**DEFENSE NUCLEAR FACILITIES
SAFETY BOARD**

March 21, 2019

Staff Report

Device Assembly Facility Seismic Hazard

Figure 1 – Comparison of horizontal and vertical response spectra derived from [3] and [4].

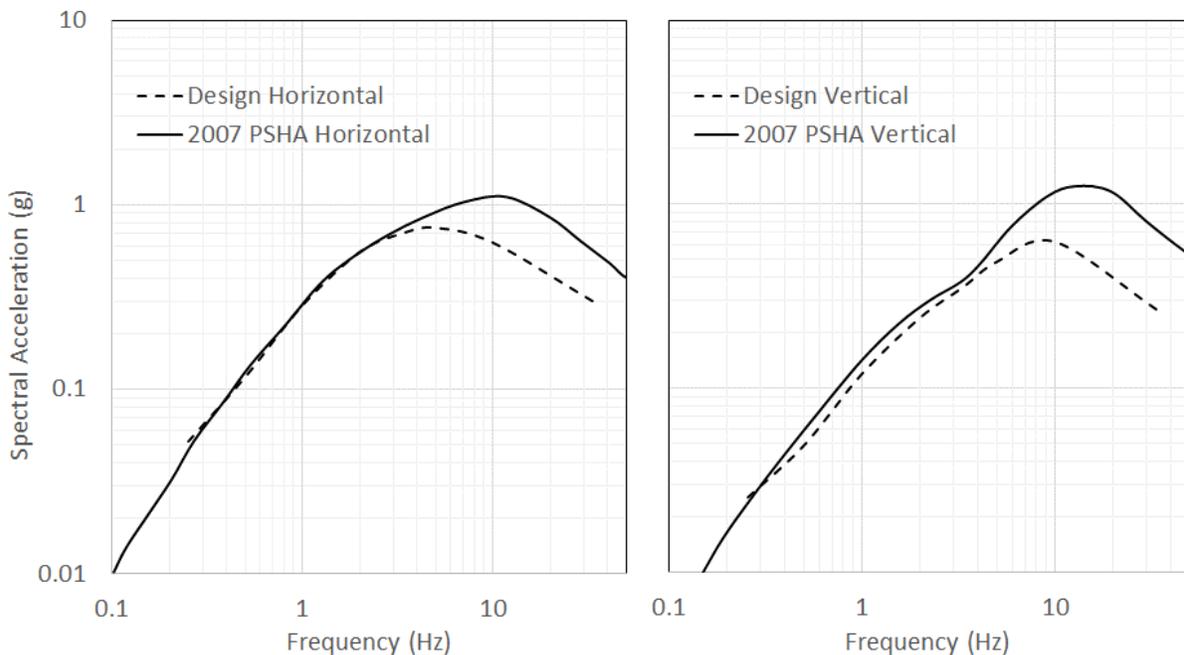
Background. As part of the 10-year assessment of the seismic hazard, the previous site contractor, National Security Technologies, LLC (NSTec), analyzed the seismic hazard for DAF in 2007 using a probabilistic seismic hazard analysis (PSHA) approach. In the 2007 PSHA [3], the ground motion response spectra significantly exceeded the previous 1995 analysis [4] for the design-basis earthquake response spectra in a sensitive frequency range for safety-related structures, systems, and components (SSCs). Safety-related SSCs are generally sensitive to ground motion between 1 and 10 Hz. The horizontal ground motion spectrum in the 2007 PSHA exceeds the horizontal seismic design spectrum at 3 Hz and above. The vertical spectrum in the 2007 PSHA also exceeds the corresponding design spectrum for the same frequency range. A comparison between the 2007 PSHA and design basis response spectra is provided in Figure 1.

Recognizing that the new ground motion exceeds the analyzed design-basis earthquake, NSTec initiated a dynamic SSI analysis using the System for the Analysis of SSI (SASSI) computer program to analyze the impacts of the increased seismic hazard. For a bermed facility such as DAF, evaluating SSI effects is necessary to obtain accurate seismic demands for the facility structure and SSCs within the facility. After the Board identified quality assurance issues with SASSI [5] in 2011, NSTec halted the DAF SSI analysis. In 2016, the Department of Energy (DOE) resolved the issues with SASSI and the Board closed the issues [6]. However, NSTec decided to delay the SSI analysis pending the 10-year seismic hazard assessment planned for 2017, given the potential that the seismic hazard could exceed the 2007 PSHA results. If the seismic hazard exceeded the 2007 PSHA results, a new SSI analysis would be required using updated PSHA results.
